From: PUBCOMMENT-OCC
Sent: Thursday, April 1, 2021 9:08 AM
To: PUBCOMMENT-OCC2; PUBCOMMENT-OPIC; PUBCOMMENT-ELD; PUBCOMMENT-WQ
Subject: FW: Public comment on Permit Number WQ0015944001

REGULATED ENTY NAME BAYOU SIDE PARTNERS SANTA FE

PERMIT NUMBER: WQ0015944001

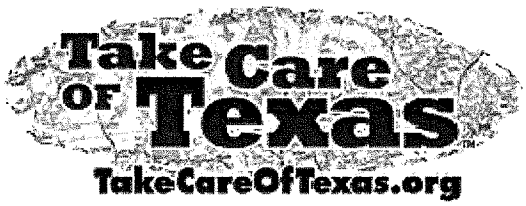
This is marked up pictures of the boundaries between proposed mobile home park and my property.

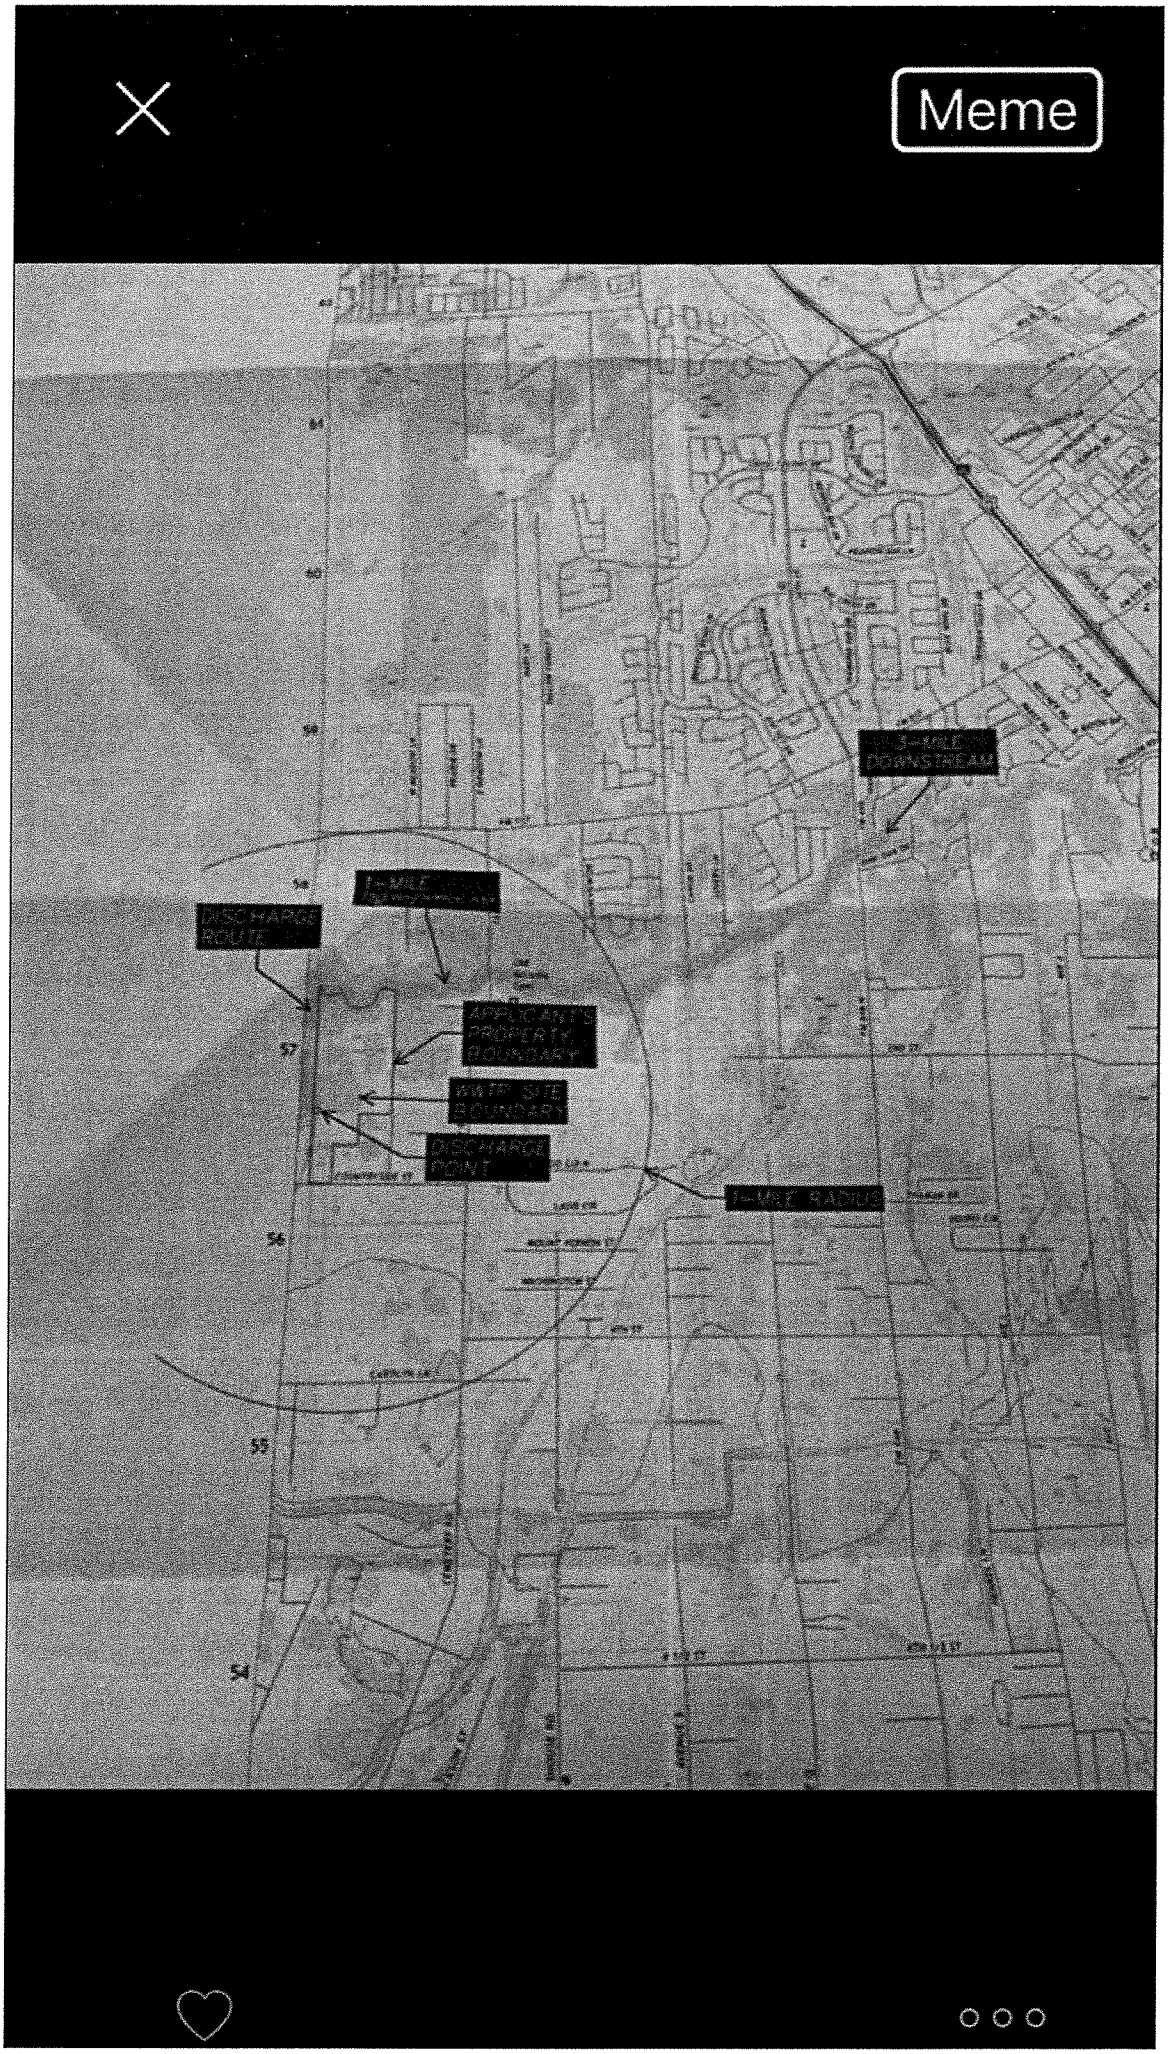
AT&T
8:16 PM
North
Water Well
50 FT from Creek
3D
Creek runs North
West
East
My property
Their
Proper
ty
Drainage Ditch--------
Pink line is proposed discharge area
into drainage ditch
Creek---------
South
61°
AQI 41
Search for a place or address

South
---Drainage ditch
Proposed mobile home park
Pink is proposed discharge area
Creek------
Creek flows North
My property
North

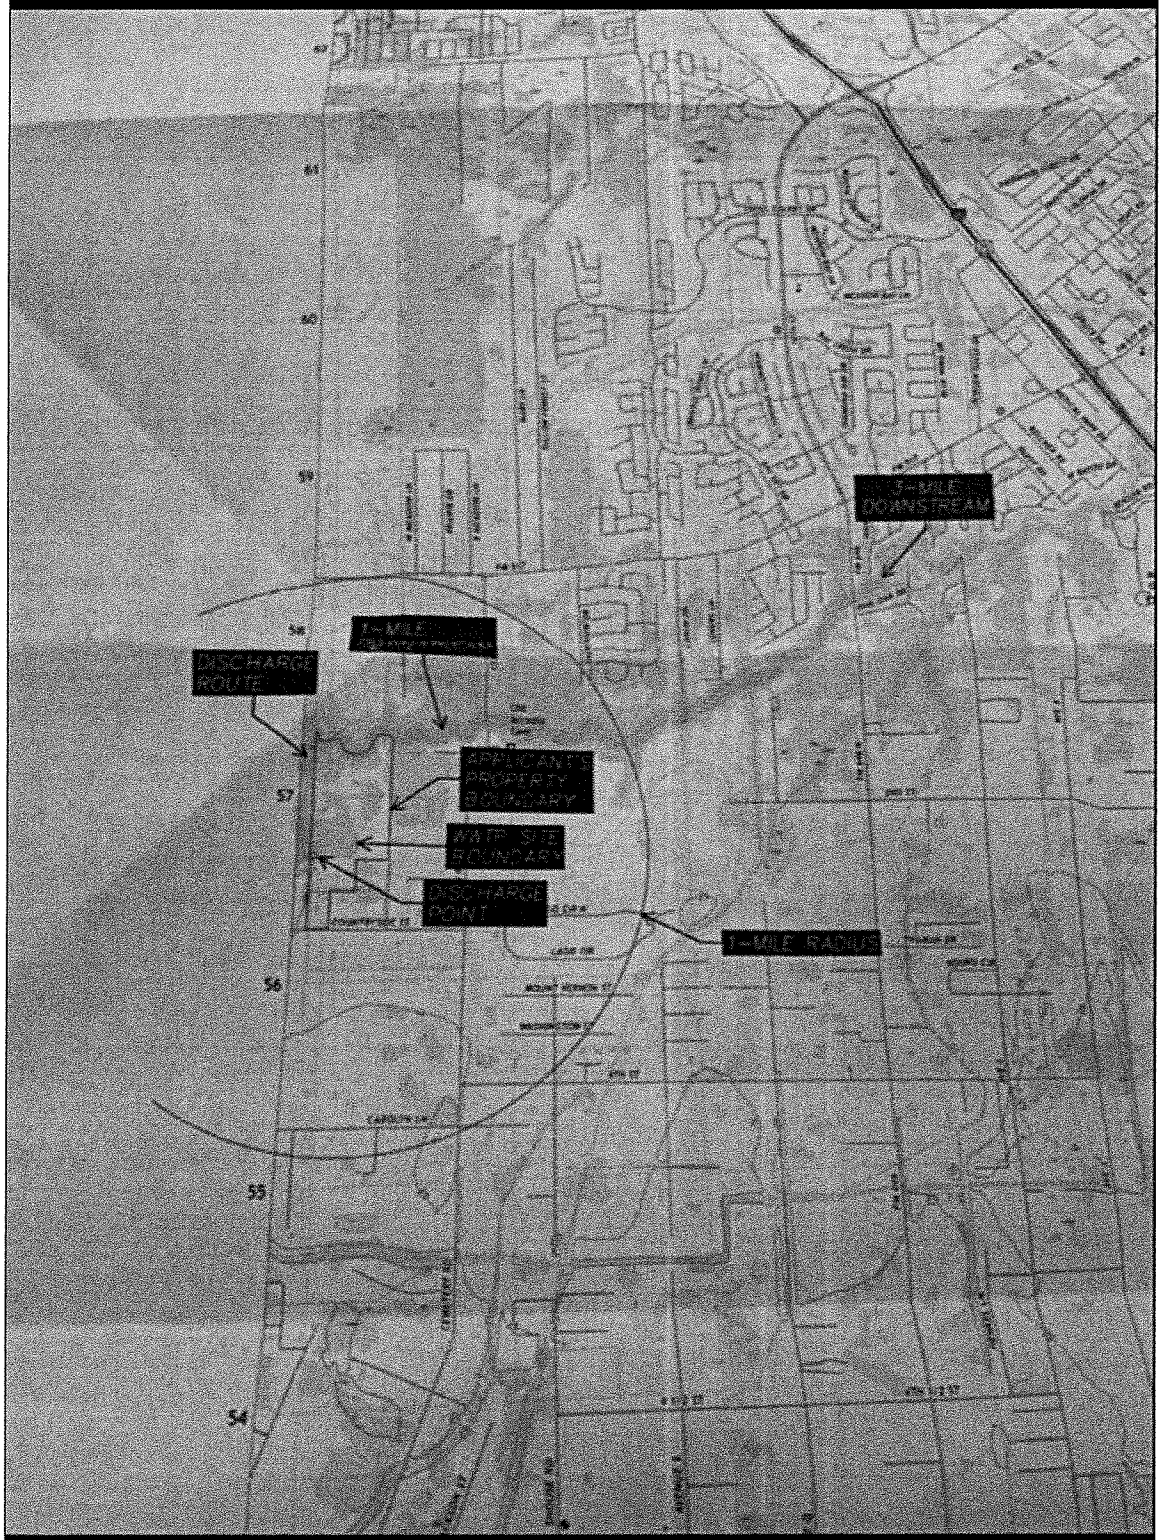
AT&T
8:16 PM
North
Water Well
50 FT from Creek
3D
Creek runs North
West
East
My property
Their
Proper
ty
Drainage Ditch--------
Pink line is proposed discharge area
into drainage ditch
Creek----------
South
61°
AQI 41
Search for a place or address

South
---Drainage ditch
Proposed mobile home park
Pink is proposed discharge area
Creek-------
Creek flows North
My property
North

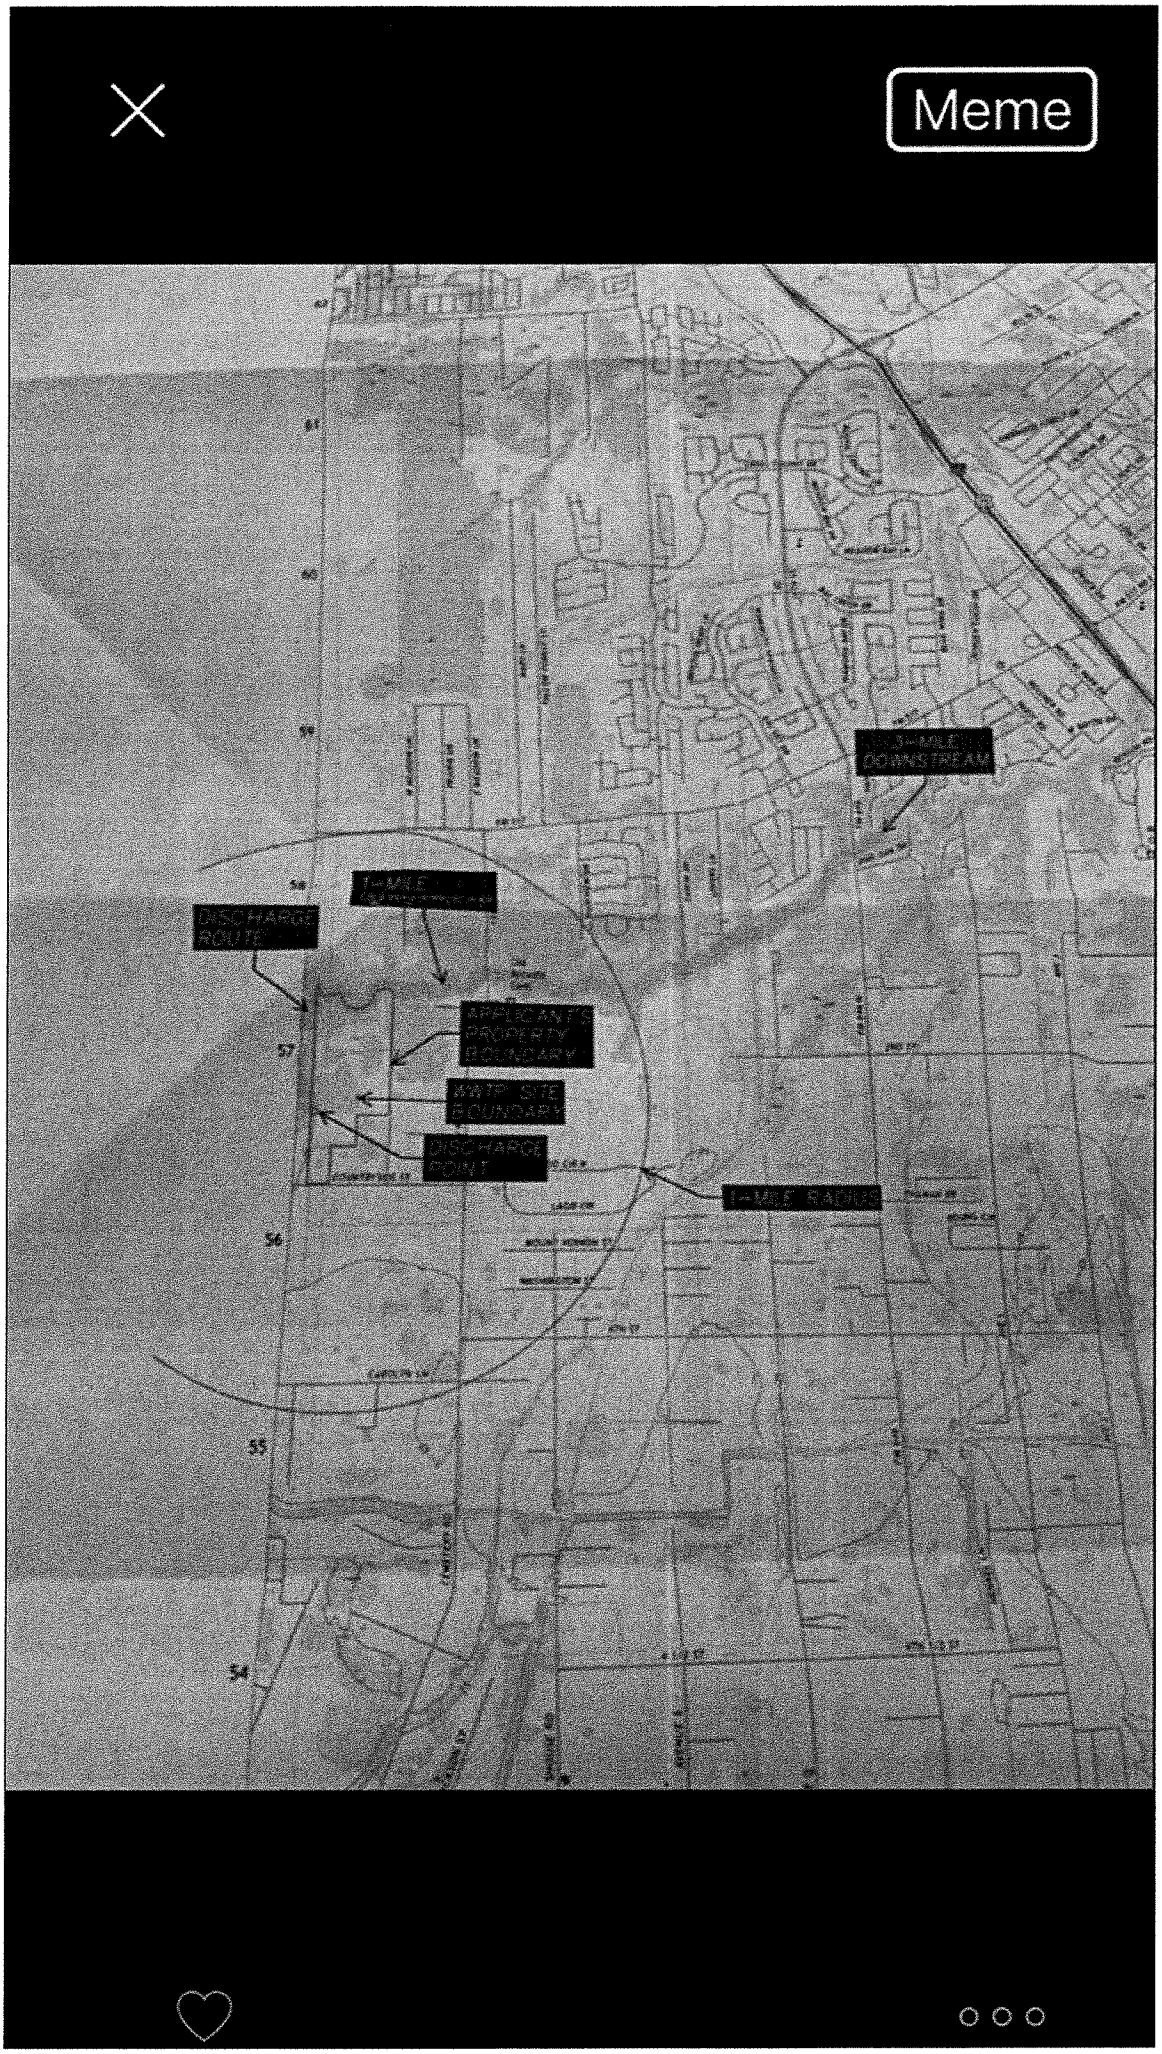
AT&T
8:16 PM
North
Water Well
50 FT from Creek
3D
Creek runs North
West
East
My property
Their
Proper
ty
Drainage Ditch--------
Pink line is proposed discharge area
into drainage ditch
Creek----------
South
61°
AQI 41
Search for a place or address

South
---Drainage ditch
Proposed mobile home park
Pink is proposed discharge area
Creek-------
Creek flows North
My property
North
